Subject: Interstate 4 from 1 Mile East of State Road 434 to Volusia County Line Value Engineering Study Recommendation Dispositions

FM: 242592-4

Interstate 4 from 1 Mile East of State Road 434 to Volusia County Line

Value Engineering Study **Draft** Report

RECOMMENDATION No. 1: Provide an additional floodplain compensation alternative in Basin 300 as FPC 300-A is impacted by a billboard

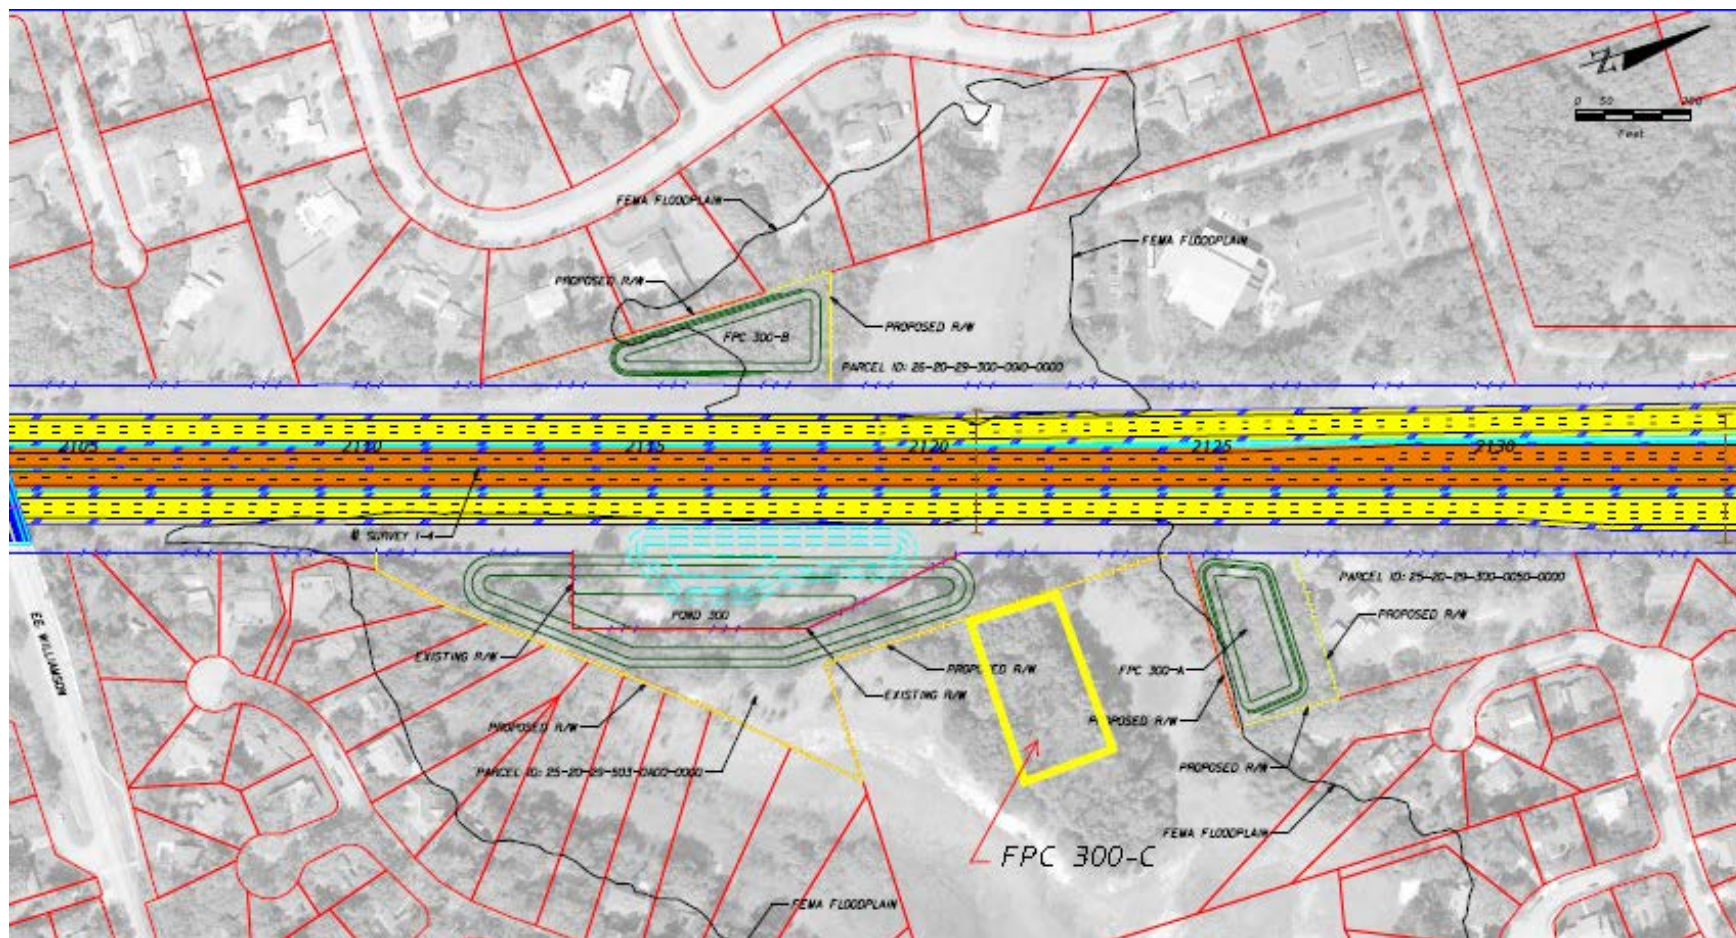
RECOMMENDATION No. 1: Provide an additional floodplain compensation alternative in Basin 300 as FPC 300-A is impacted by a billboard

The PD&E Documents show floodplain compensation pond, FPC 300-A, located on a parcel on the east side of I-4 (parcel ID: 25-20-29-300-0050-0000). It was recently determined that there is a billboard located within the parcel. The location of the billboard significantly impacts the potential storage within the pond site. Due to the billboard, FPC 300-A has a R/W cost of \$1,586,000. The alternative site, FPC 300-B, located on the west side of I-4, has a R/W cost of \$441,000. As there has been public concern regarding loss of the tree line between FPC 300-B and I-4, it is recommended to provide an additional alternative site for floodplain compensation in this area.

It is recommended to provide an additional site for floodplain compensation (FPC 300-C), located south of FPC 300-A, and within the area adjacent to Grace Lake. As there is no contour information for this area, it is not possible to determine if this is a viable alternative until survey is obtained. The R/W cost of this site was determined to be the same as FPC 300-B (\$441,000).

Not Accepted. The third floodplain compensation alternative in Basin 300 is FPC 300-C. FPC 300-C is an option that was recommended by the Value Engineering Study due to the impacts to an existing billboard within the FPC 300-A parcel. The potential pond site is located within the floodplain of Lake Grace, just east of Pond 300. After receiving additional topographic survey for the site, it was determined that it is not a feasible option. The existing ground elevation for the majority of the potential site is lower than the floodplain elevation of 67.00 ft NAVD. After this alternative was eliminated, FPC 300-A was reconfigured around the existing billboard as not to impact it.

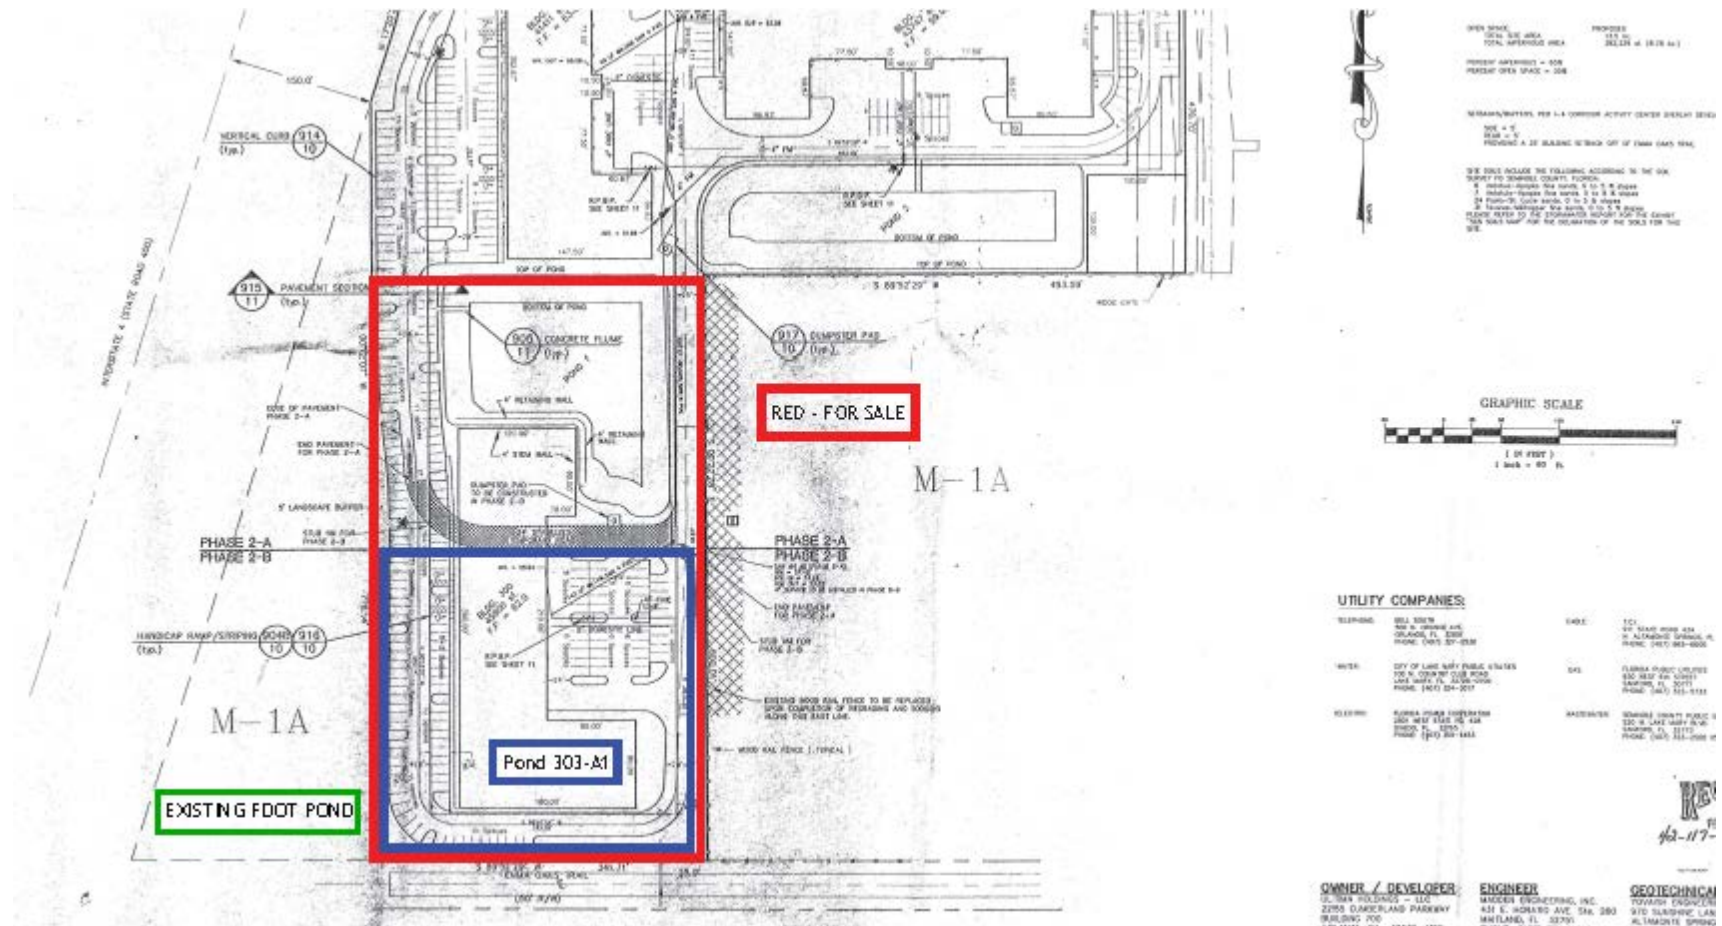
The PD&E Documents show a partial taking from a 4.39 acre site currently listed for sale. The site is primarily vacant, but was previously permitted for flex space development in conjunction with adjoining existing rental improvements. As part of a master planned development, a portion of the 4.39 acres is improved with a retention pond, interior access/circulation road, and limited parking. Some of these completed site improvements appear to serve the proposed flex development, while others would be removed or relocated when the new space is constructed.

- Potentially increased right of way cost.
- Added burden of joint use pond permitting and maintenance.

Not Accepted. This pond site can be shown to take the entire property that is for sale, which would result in a joint use pond or two ponds under FDOT control. This pond alternative (Pond 303-A1) could be the preferred option if the billboard cannot be relocated on the other pond alternative site (Pond 303-B2).

RECOMMENDATION No. 3: Make Pond 303-B2 the preferred pond by relocating the billboard within the site

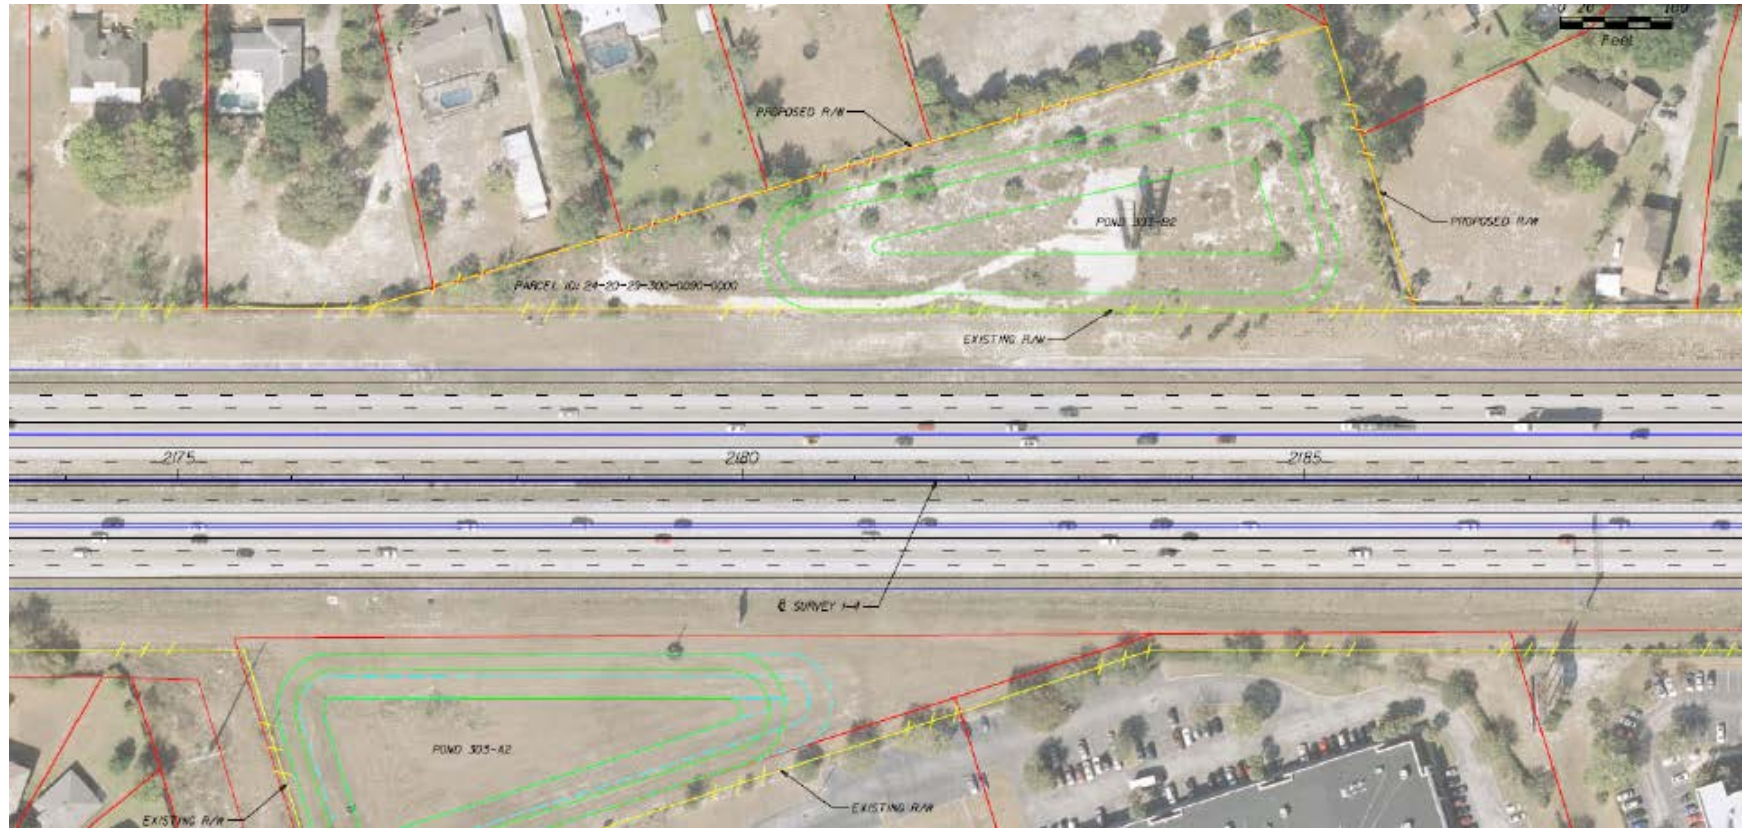
The PD&E Documents show Pond 303-B-2 impacting the billboard outdoor advertisement (ODA) sign constructed in 2011.

Accepted. Currently, central office is evaluating the billboard on this site for relocation. If the billboard can be relocated on this site, this pond will be the preferred alternative (Pond 303-B2).

RECOMMENDATION No. 4: Maintain the design variation in the Ultimate section though the entire

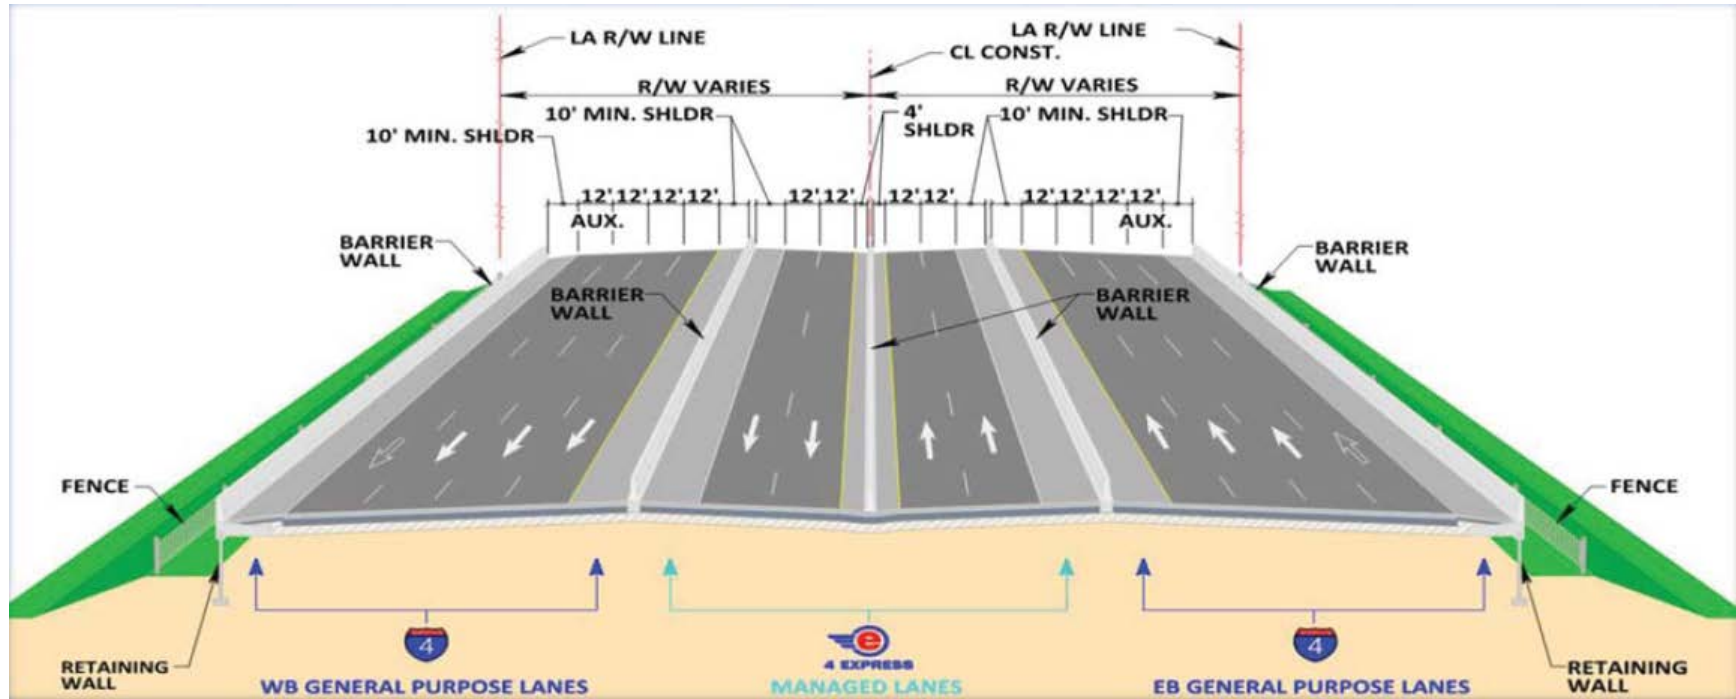
The PD&E Documents show providing a 6-ft. inside median shoulder width for the Express lanes and providing 12-ft inside and outside shoulder width for general use lanes.

Accepted. The design variation will be used throughout the section.

RECOMMENDATION No. 6: Relocate the sidewalk off of back of curb at the BB&T Bank on Lake Mary Blvd. by purchasing an easement or right of way to avoid utility relocations

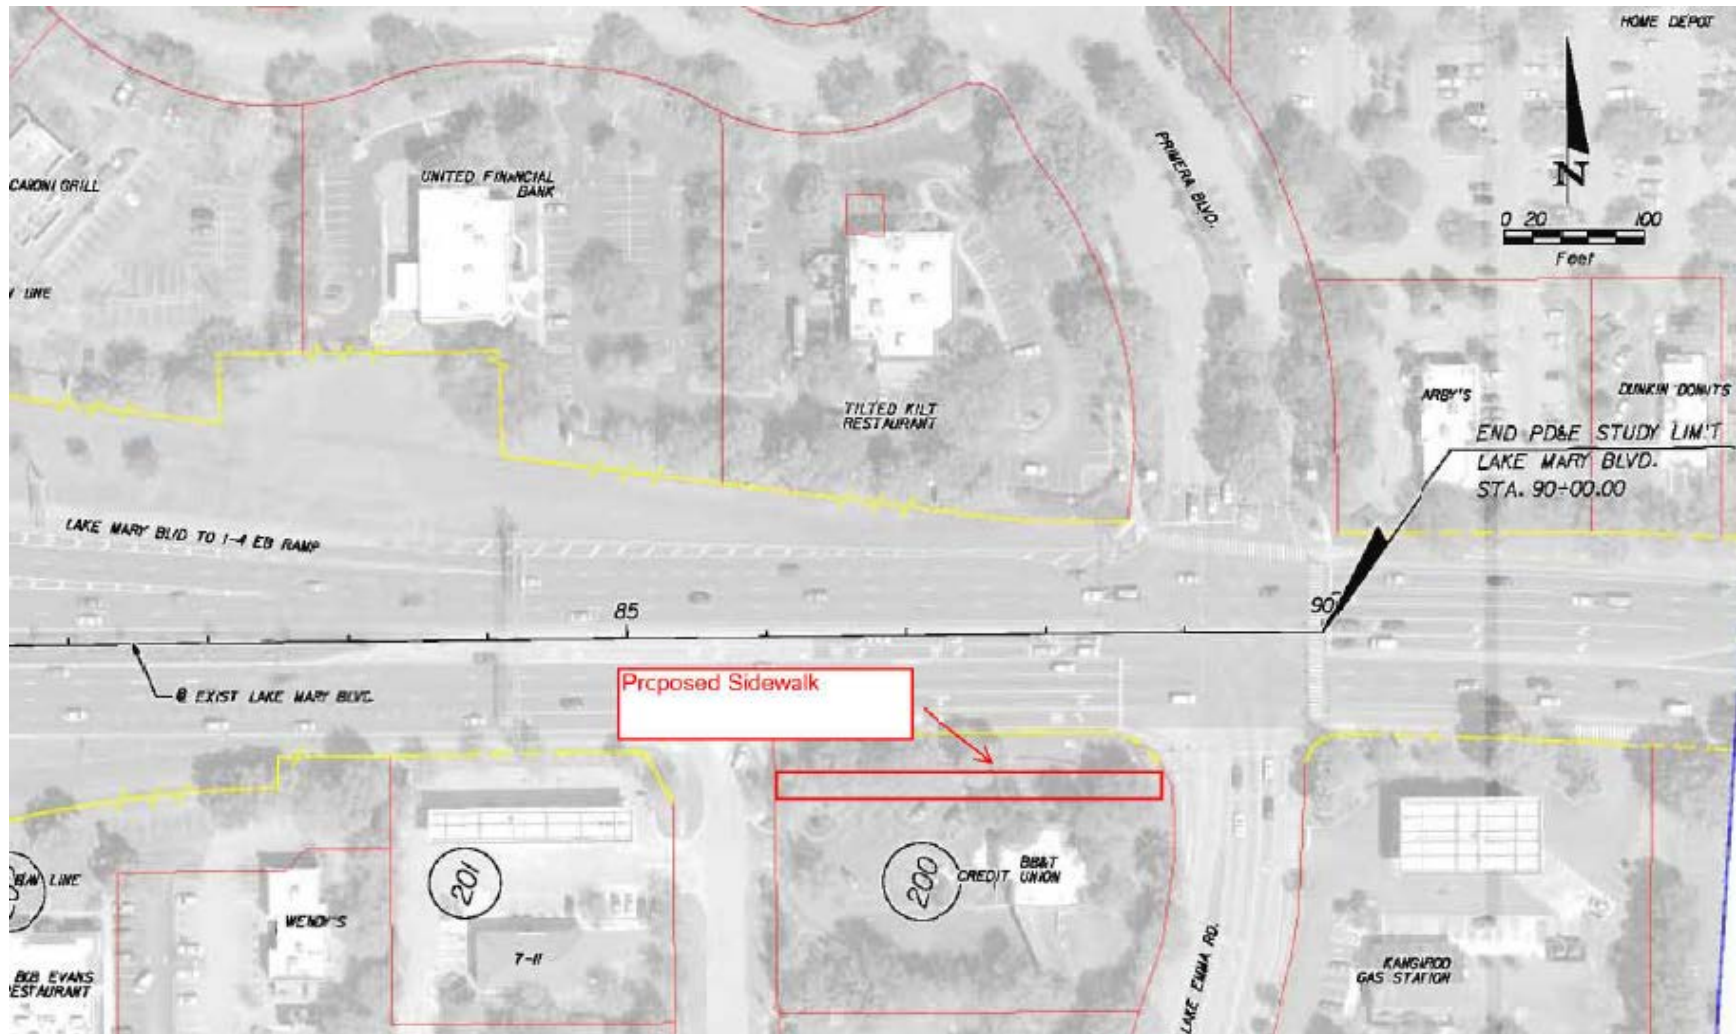
The PD&E Documents show leaving Lake Mary Blvd. as is except for replacing the bridge with longer spans across the new typical section.

Accepted. Costly utility relocation could be avoided by moving the sidewalk back outside of the right of way.

RECOMMENDATION No. 7: Don't build the 6-ft. sidewalk on the south side of the bridge

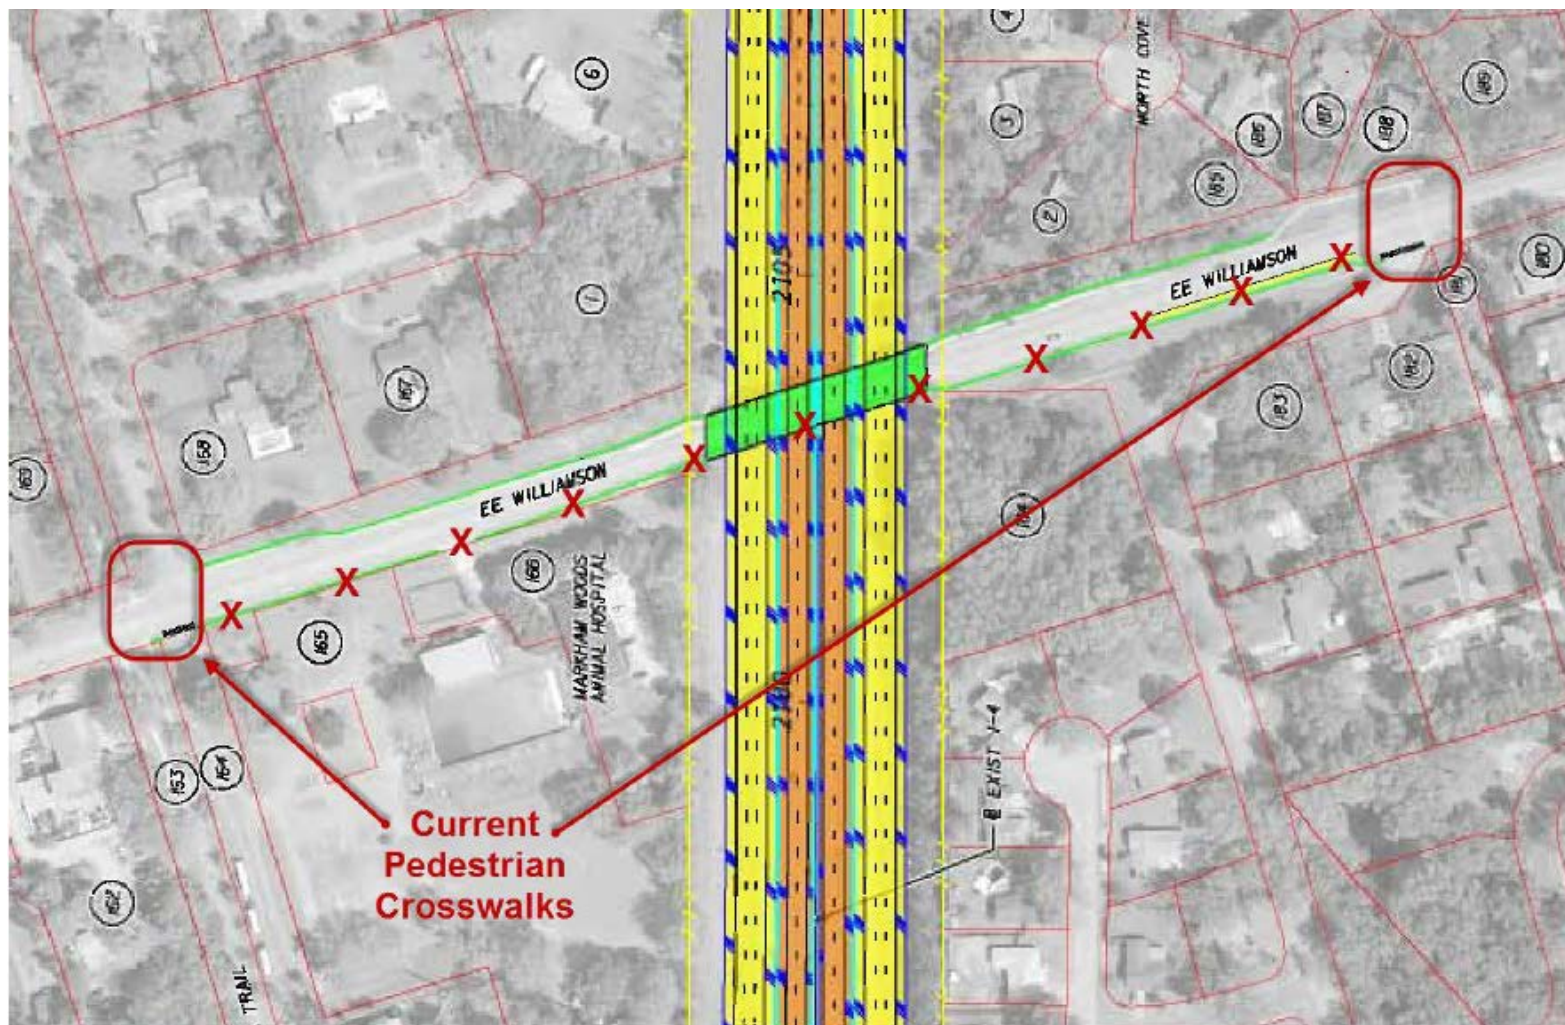
The PD&E Documents show adding a 6-foot sidewalk on the south side of the EE Williamson Road bridge replacement.

Replace the EE Williamson Road Bridge without adding the 6-foot sidewalk on the south side, and leave the trail on the north side for pedestrian access. There are pedestrian crosswalks across EE Williamson Road about 600 feet on either side of the bridge.

Not Accepted. The EE Williamson Road Bridge will be replaced and sidewalks will be provided on both sides to maintain consistency with the approaches on each side of the bridge.
